Your ref: 5.2015.515.1 Our ref: DP/11/01779

# LOT 301 (NO. 471) BEAUFORT STREET, HIGHGATE - DEVELOPMENT

I refer to your letter dated 26<sup>th</sup> November 2015 regarding the above application. In accordance with the Western Australian Planning Commission's (WAPC) Notice of Delegation dated 10<sup>th</sup> June 2014, the following transport comments are provided by the Department of Planning.

Figure 1. Aerial map with MRS reservations

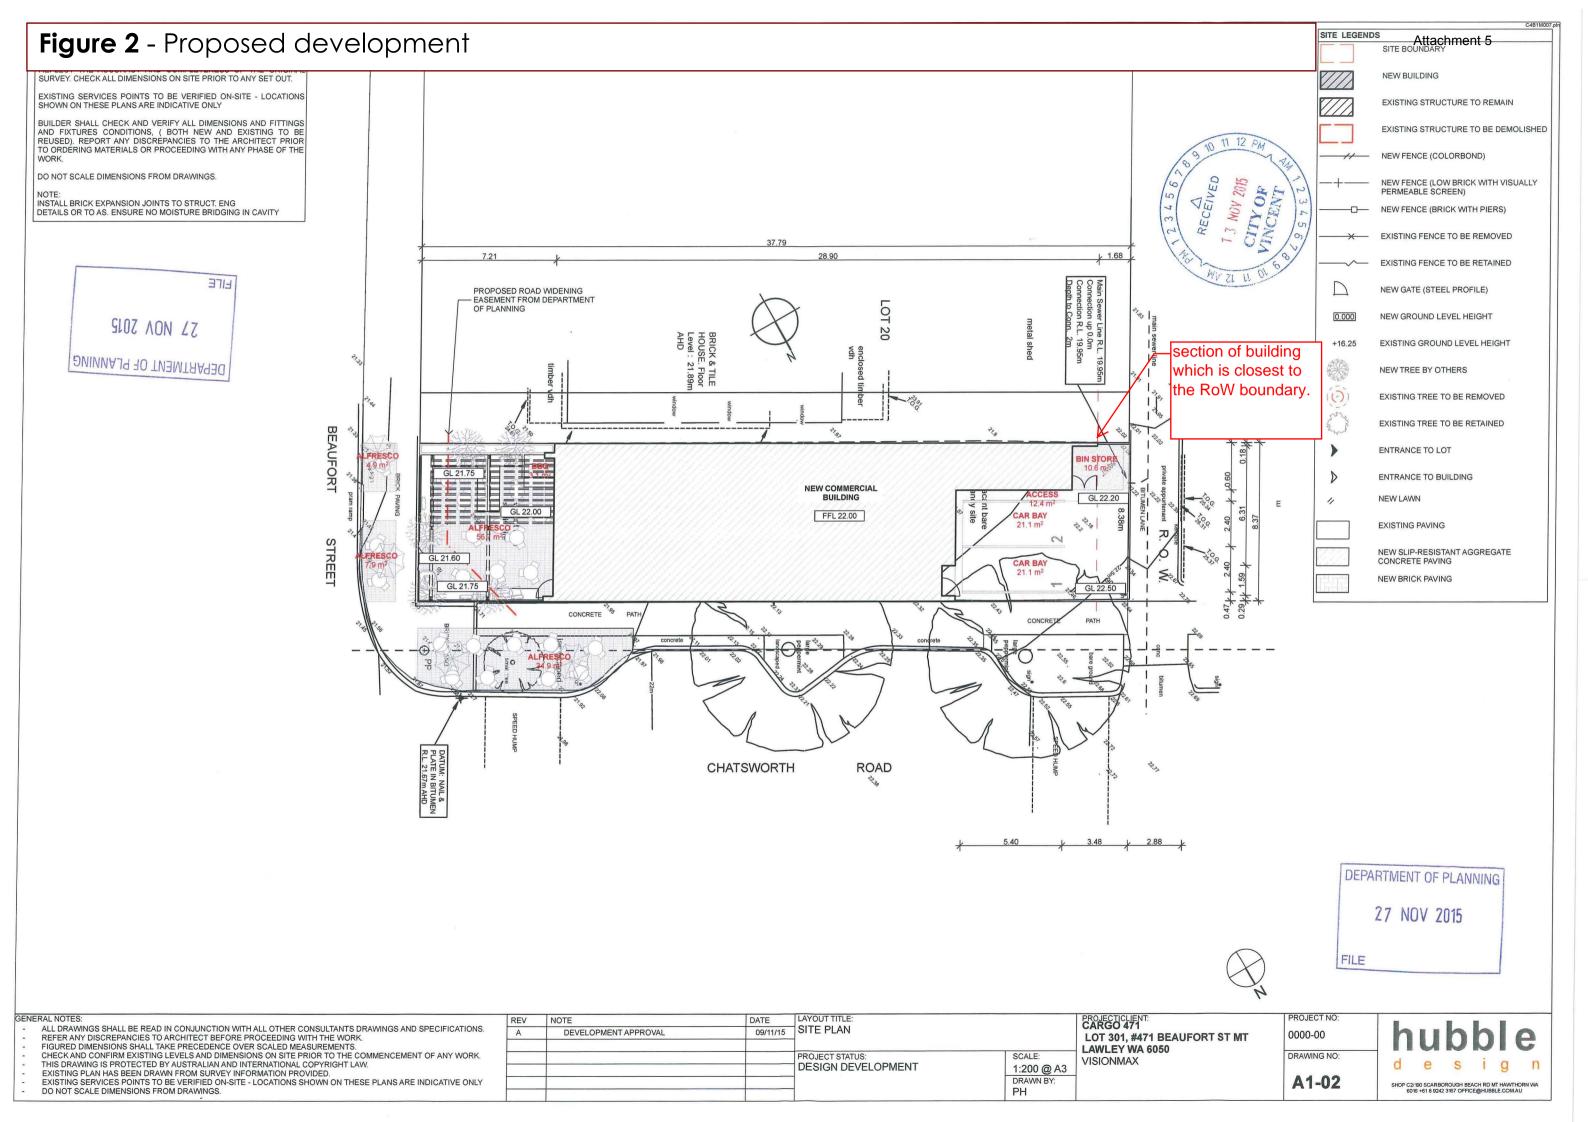
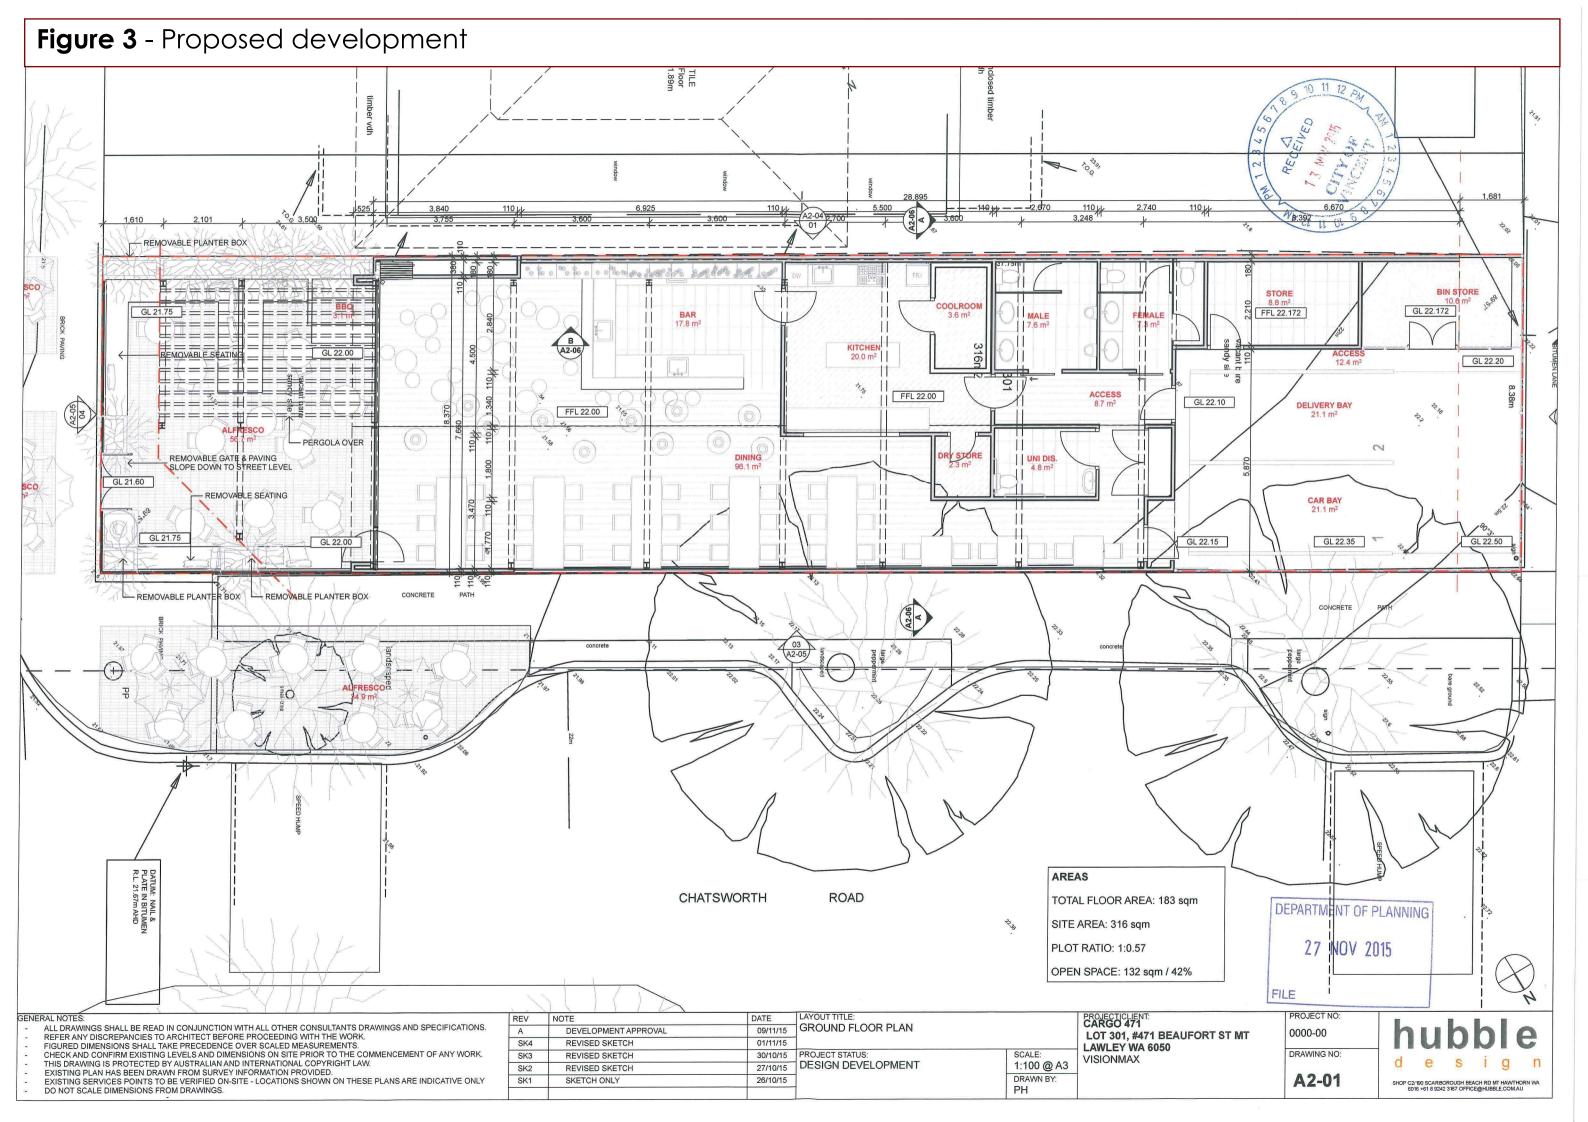
Lot 301 is affected by the ORR reservation for Beaufort St, as shown in *Figure 1*, and *Figure 3*. The reserve boundary is shown in the development plans, and all structures proposed within the reserved area (seating, planter boxes, BBQ, pergola, gate and paving) have been identified as removable.

In principle, the Department does not support development of a substantial nature within ORR reserved land. However, given the type and nature of the proposed development, the Department would be prepared to support the use of the reserved land on a temporary basis only and subject to the condition that the land owner enters into a deed of agreement with the WAPC that the presence of the development on the reserved land

Lot 301 abuts Beaufort St, Chattsworth St and a 3m wide Right of Way (RoW), as shown at *Figure 1*. The lot does not appear to have any constructed crossovers, but would be accessible for vehicles via the RoW. The proposal does not explicitly show where any crossovers would be located, however a car and delivery bay area is shown at the rear of the lot, abutting the RoW and Chattsworth St, as shown in *Figures 2* and *3*, and the configuration suggests access will be via the RoW.

By setting back all parts of the development 1.5, the proposal is contributing to the future widening of the RoW to 5-6m, however it is noted that the proposed bin store area appears to be encroaching into the 1.5m setback area, therefore it is strongly recommended that, the design be modified to clearly demonstrate that no part of the bin storage area (or any other part of the development) be located within the 1.5m setback.

As vehicle access is to be provided via the existing 3m wide RoW, the Department strongly recommends the city adopt a coordinated and long term approach to the future upgrading of the RoW to 6m, (or 5m, with 0.5m wide setbacks on both sides), and that the City require no part of the proposed development, associated car bays, bin storage area, or other permanent structures to be located within 1.5m of the RoW boundary.
